# MARCO POLO - 101 W 33RD STREET

Date	Description
05.19.2022	Progress Set

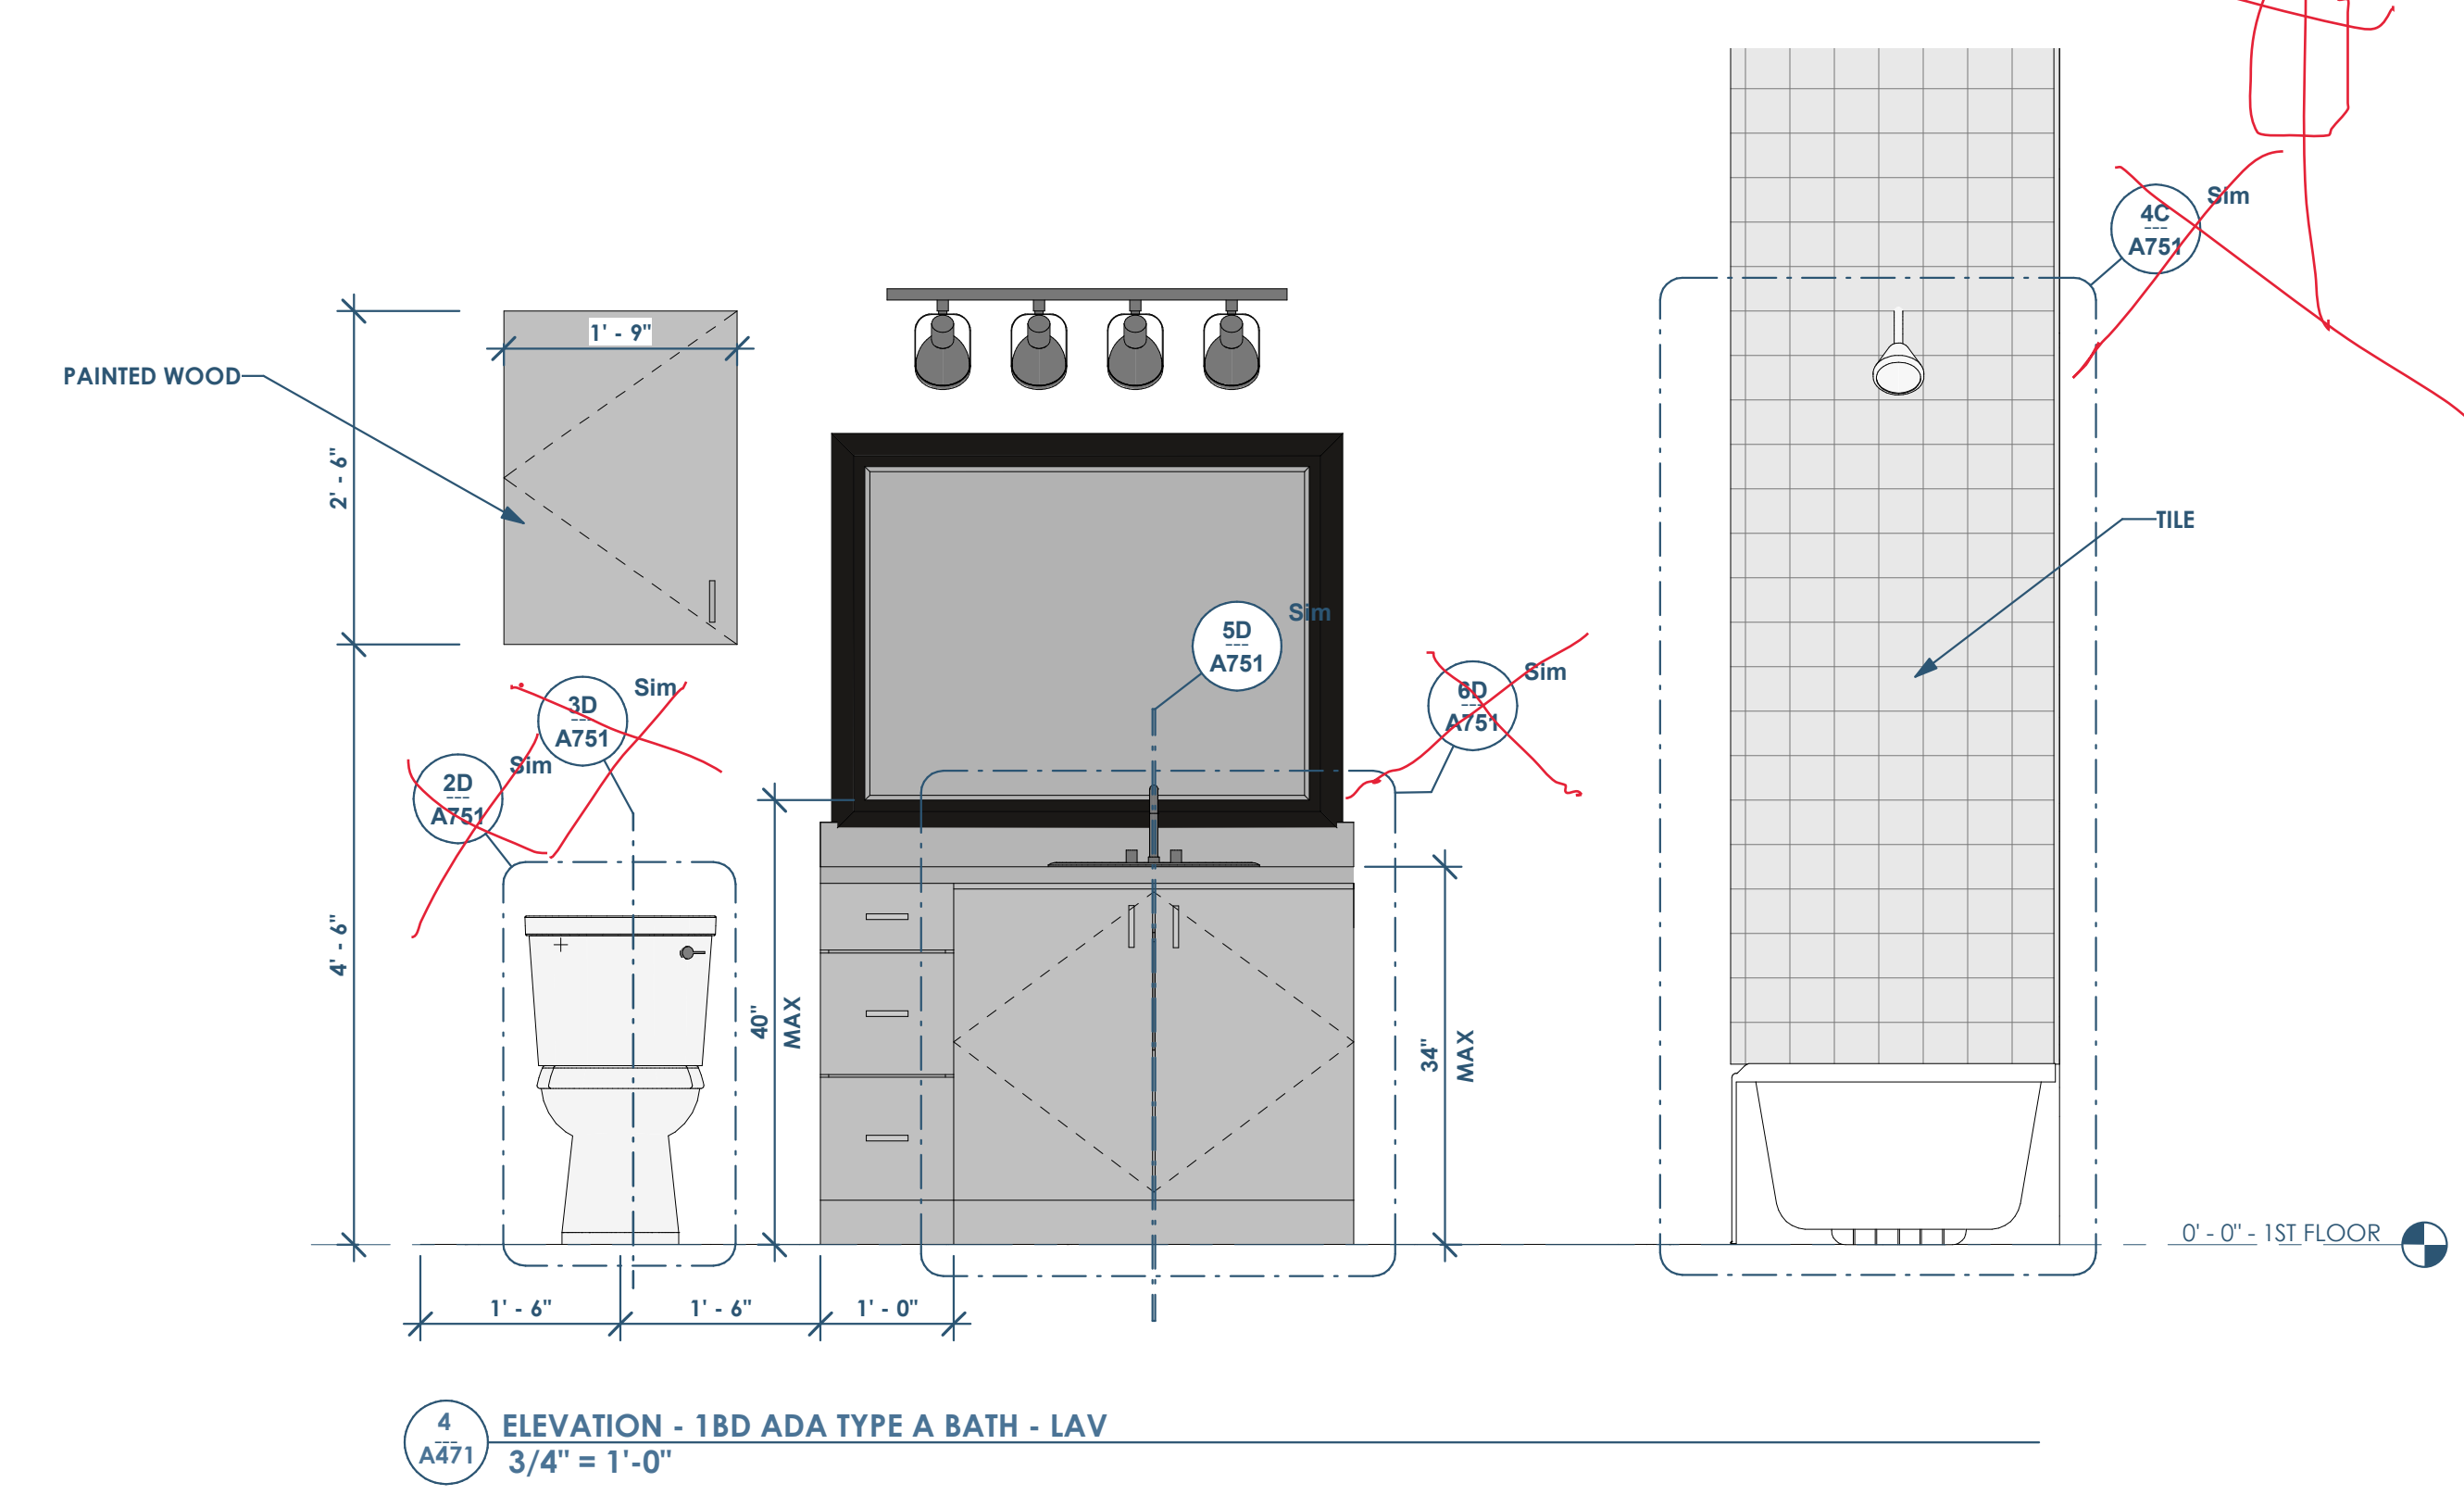
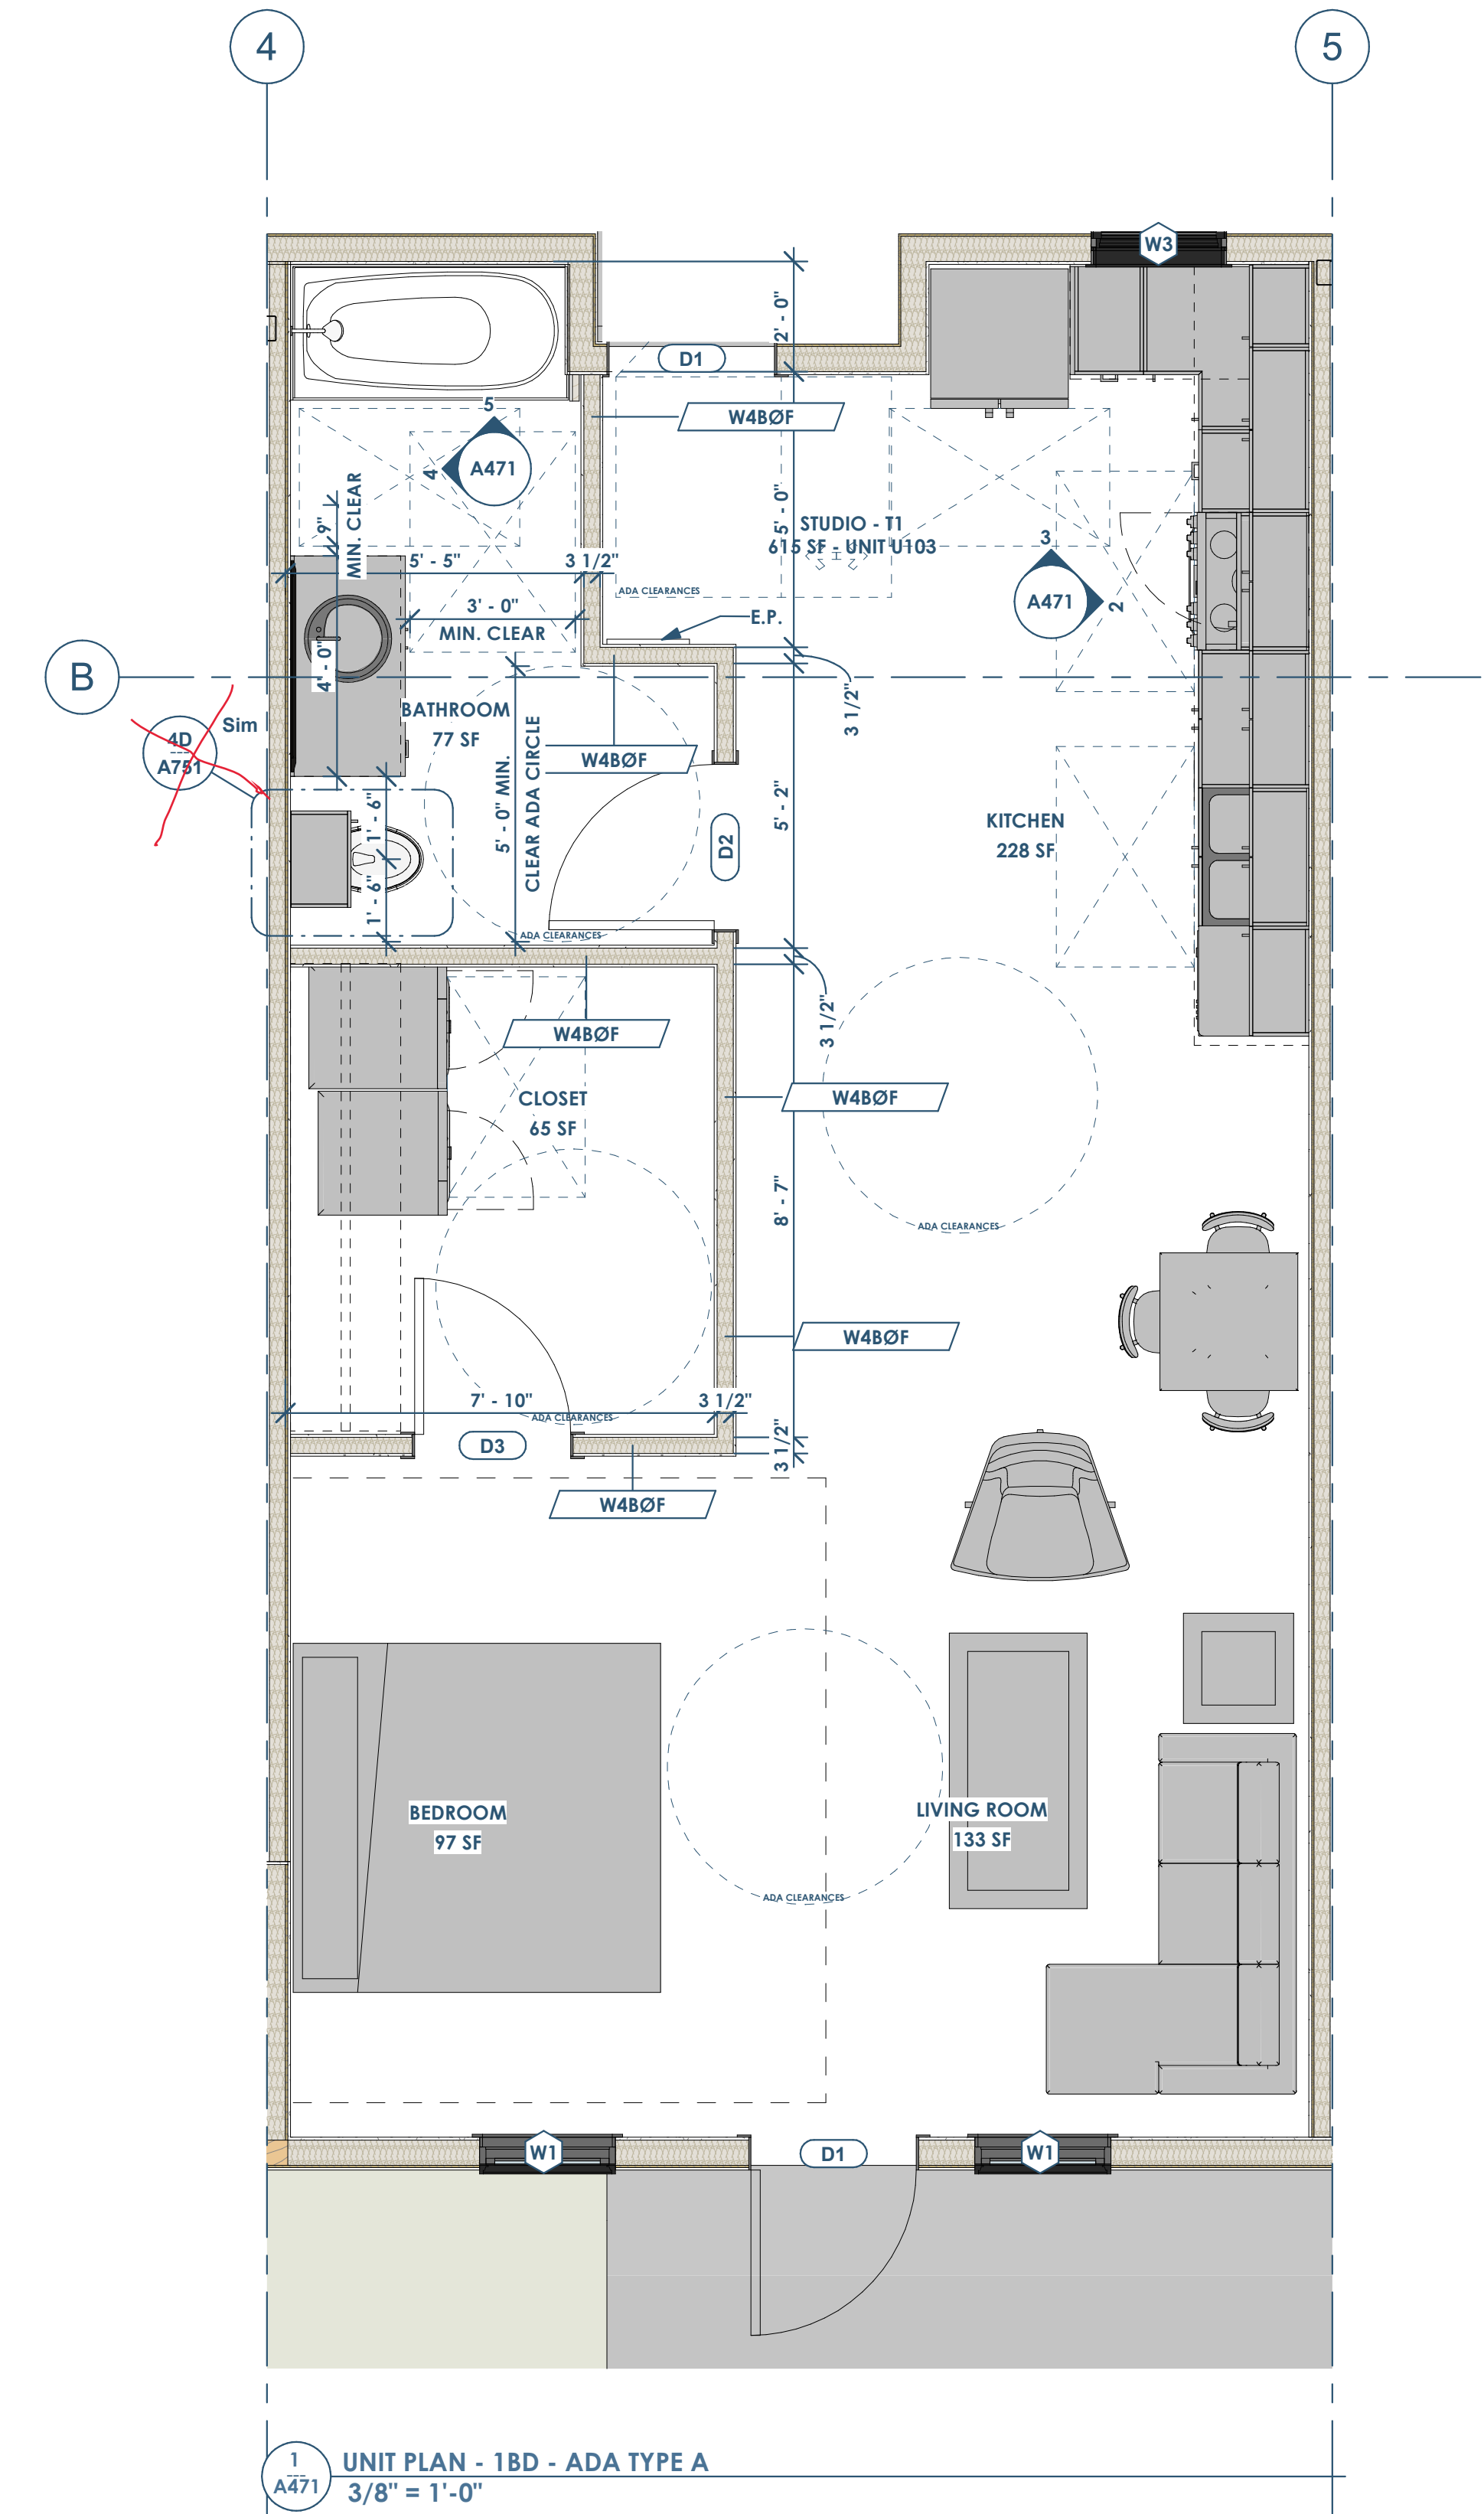
REFERENCE COMMENTS AND ADD GENERAL NOTES PER A470
